SUBJECT: ADDITIONAL INFORMATION

Subject: Brown's Business Development Preliminary Engineering Review

In Answer to: Crestline Engineers Review

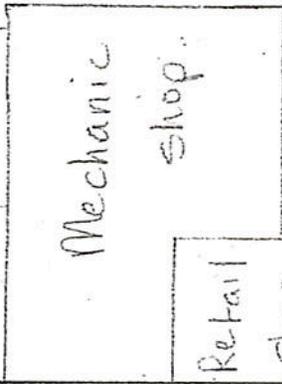
- C) Zone "C" requires a twenty five (25) foot rear yard setback. The proposed storage units are shown on the site plan to be at the property line, are in conflict with the twenty five (25) foot rear yard setback.
- D) Total lot coverage of all buildings shall not exceed sixty percent (60%). As shown on the site plan, the proposed repair shop is 3,264 S.F, the proposed attached office is 1,248 S.F, and the proposed storage facilities cover approximately 4,200 S.F. The two hundred seventy (270) foot by one hundred fifty five (155) foot property is 41,850 S.F. The buildings cover approximately 21% of the lot, which is in accordance with this ordinance.
- E) Required parking shall have alley access and meet parking requirements as set in Section 16 of the New Meadows City Zoning Ordinance. Parking is addressed in this review after the completion of the Section 8 review.

Note: The parking spaces located most adjacent to Hwy 95 are not accessible and are not acceptable as shown on the submitted site plan.

- A) **Parking Dimensions** – The proposed parking spaces on the site plan are approximately ten (10) feet by sixteen (16) feet. This ordinance requires that the standard parking space is nine (9) feet in width by twenty (20) feet in length. The proposed parking spaces are required to be adjusted on the site plan be in accordance with the standard parking space. The proposed parking spaces meet compact car parking space requirements, but no more than 25% of spaces in a parking area may be designed as Compact parking spaces.

The parking spaces shown on the site plan located perpendicular to the secured storage space are located too close to the secured storage. Per the required parking aisle widths in Section 16-5 there must be twenty four (24) feet between the parking spaces nearest to the secured storage facility based the angle of the spaces as shown on the proposed site plan. It appears that the spaces are located approximately twelve (12) feet from the secured storage area.

- 5) Improved parking areas shall have at least 25% of the improved parking and circulation areas for snow storage. Snow storage locations have not been provided on the site plan to verify the 25% requirement. It is our recommendation that a revised site plan be submitted showing the areas reserved for snow storage.

According to Crestline Engineers request for a revised site plan, we have submitted the revised site plan and made all requested changes according to their recommendations

A, B & C) All the setback requirements have been met in the requested site plan, with the conditional use permit having been submitted and approved by Planning and Zoning for the storage buildings on the alley side. We now have a 30' setback on the rear yard.

A) All of the parking has been changed on the revised site plan. Every parking spot on our lots are 10' wide and 20' long, except the parallel parking. The parallel parking has compact parking in every

21-6 – Design Criteria – Our revised site plan shows the landscaping that we will put in place to detain and retain storm water on site. The north 30' lot on our property abutting the City's McLain Street will be sloped at a 1 ½' to 1' drop down to the rest of the lots in accordance with our reclamation plan. That 30' will now be somewhat longer because of the slope, and will be seeded with grass and shrubbery to soak up and stop most if not all runoff on it. The rest of the lots already have a gradual slope to the east which we will use to our advantage and place a berm the full length of our Highway 95 frontage to stop any other runoff that may occur. That berm will have a

5) Our revised site plan shows a 60' X 143' secured storage that is fenced from the rest of the lots. That secured storage will be used in winter for snow storage as well as the last landscaped lot that is 30' X 155'. That is a third of our property which is more than the 25% that is required.
